**TECHNICAL DEPARTMENT**

October 31, 2013

**Project: City of Rapid City 2011 Storm Damage Recovery Project**

**Firehouse**

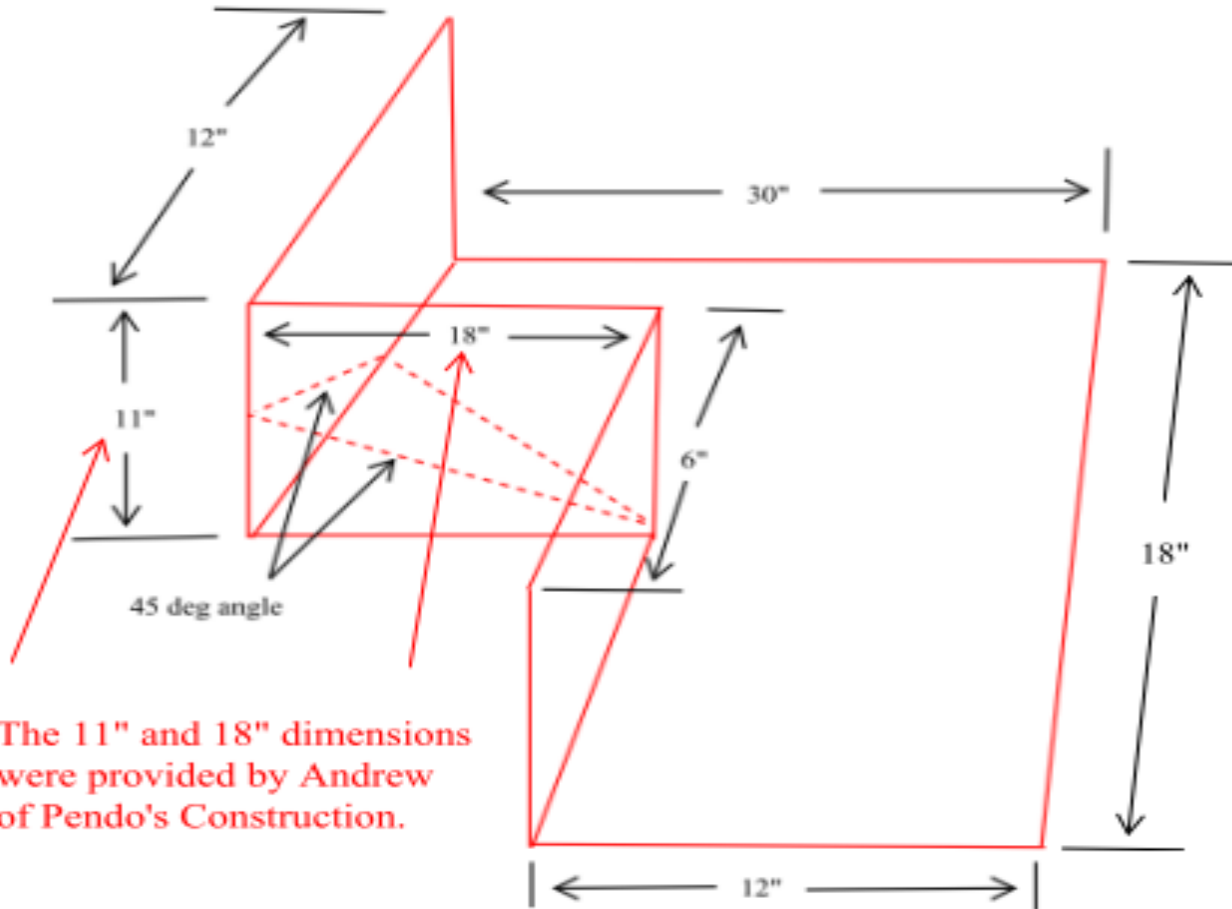
The two panels closest to the parapet wall will need to be removed so the new side wall flashing can be installed. This is due to the improper installation of the side wall flashing. This is the same for both sides of the roof.

**Firehouse**

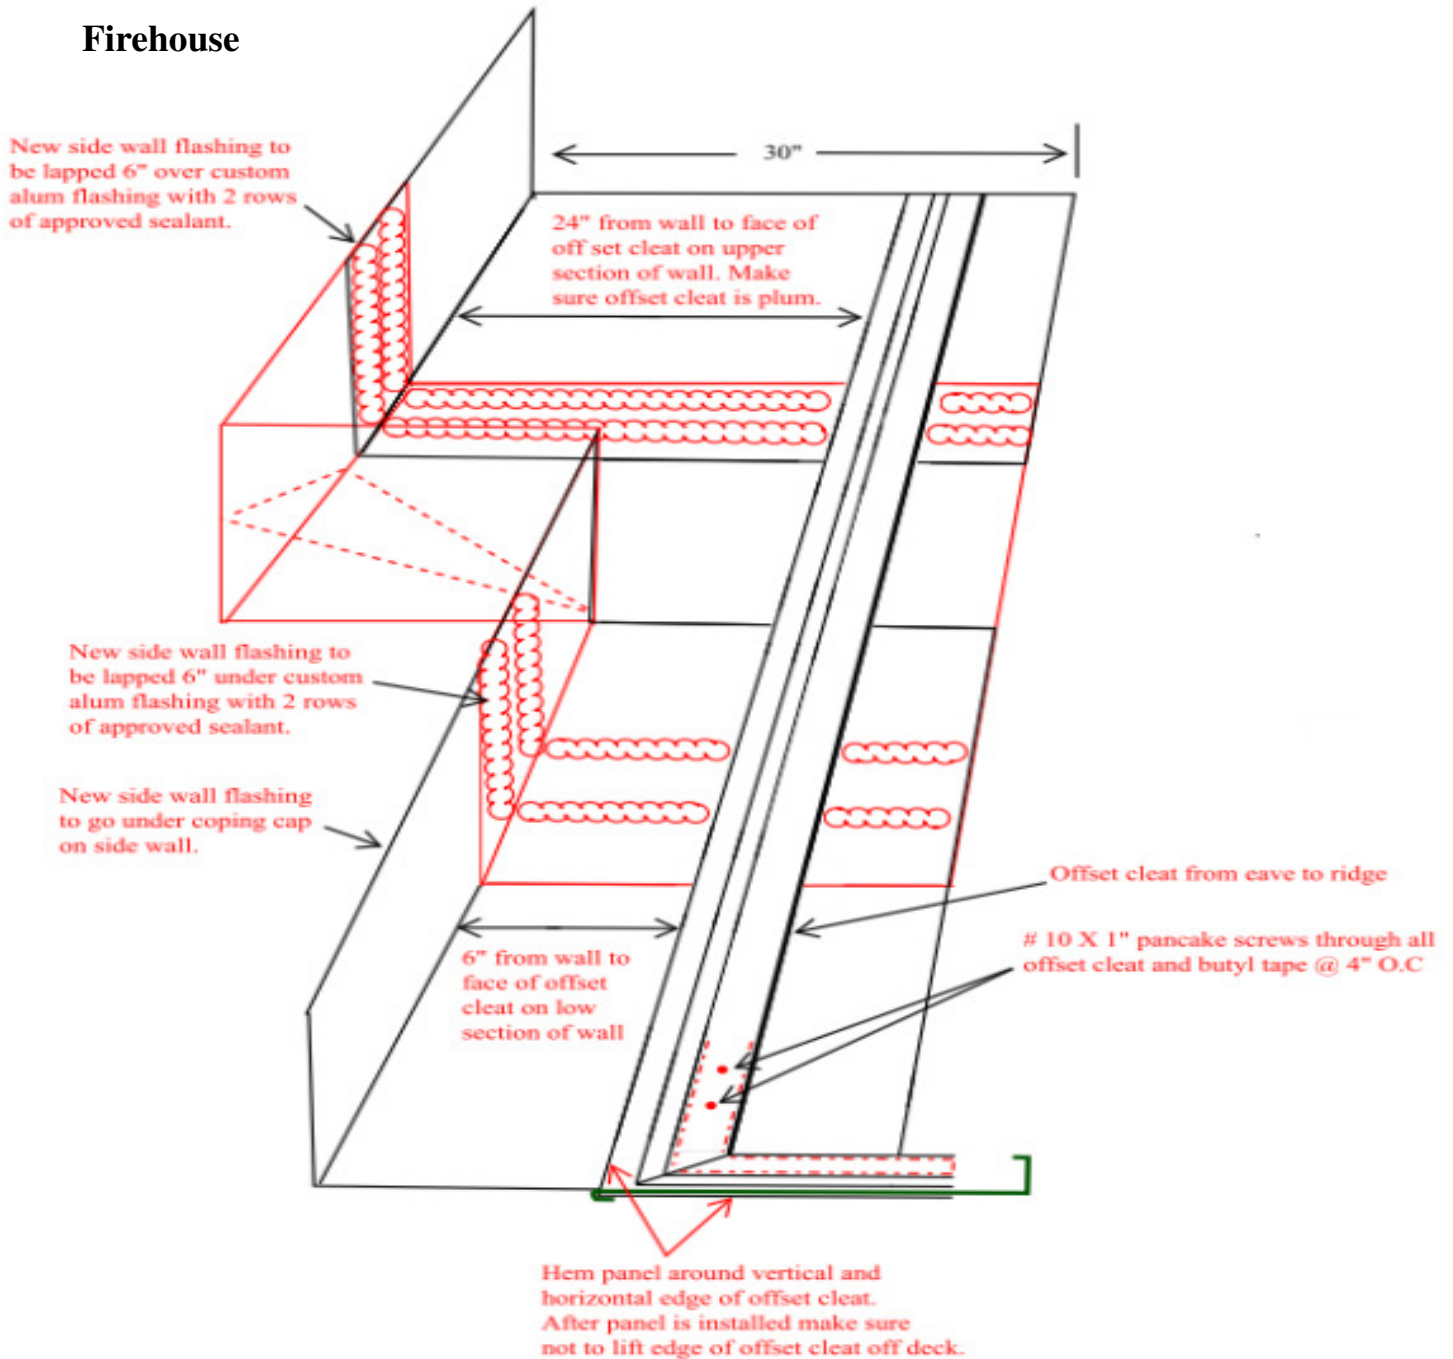
The 11" and 18" dimensions were provided by Andrew of Pendo's Construction.

This is to be .050 alum with welded corners and cricket. This is to be used at the parapet wall on the firehouse. Two will need to be made, this one and one for the other side which will be the opposite of this one.

Roof pitch will be required for vertical sections of this custom flashing.

**Firehouse**

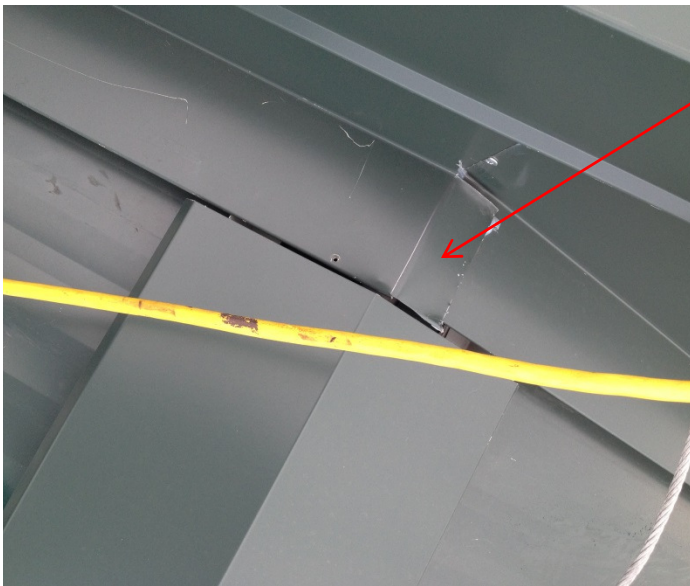
Remove head wall flashing and Z Closure.

Remove gable flashing and repair seam.

Install new Z Closure per installation details and extend vertical Z Closure per installation details. Check all vertical Z Closures on the building for proper lap and correct direction of lap so not to buck water.

Install ridge cap over side wall flashing.

**Firehouse**

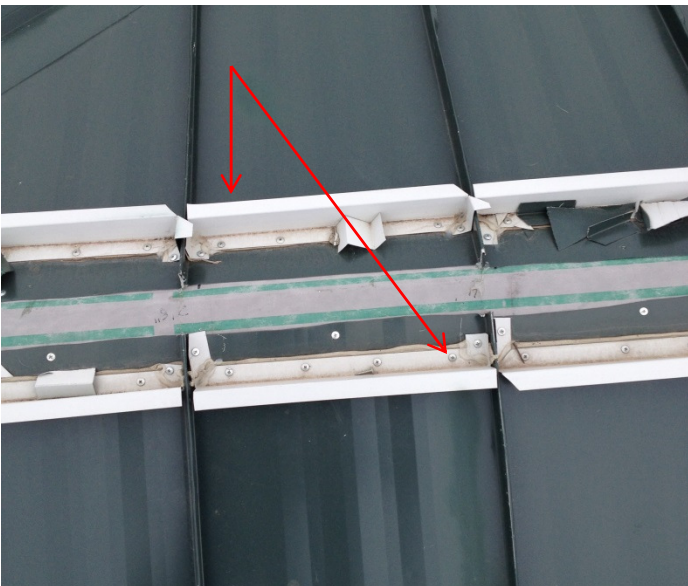
This side wall flashing is not installed to the installation detail. Remove existing flashing and install to proper side wall detail.
